Office Action Summary

10/696,463

DETAILED ACTION

FIG. 3E

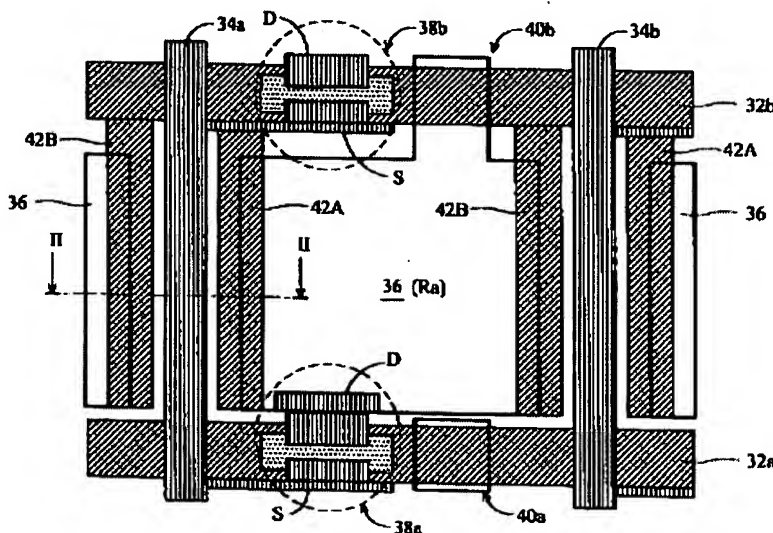
Claim 31 is objected to because of the following informalities:

Newly added limitations as to "... overlaps across the switching element" is considered incorrect [not the disclosed invention]. Please reference Applicant's Figure

3E of the elected invention. 42A overlaps the extension portion of data line 34a that runs from 34a to the source of the TFT, 38b, at S [see instant Specification, page 6 (pages not numbered), lines 8-10].

Please note that extending light shield 22a of APA to connect to gate line 12a would result in overlap with the extending portion of 14a [applicant's claim 31].

as per the teachings of Okada [this would result in overlapping the extension portion of the data line near the switching element or TFT as in Figure 3E].

For examination purposes, examiner will consider overlap per elected embodiment as shown in Figure 3E.
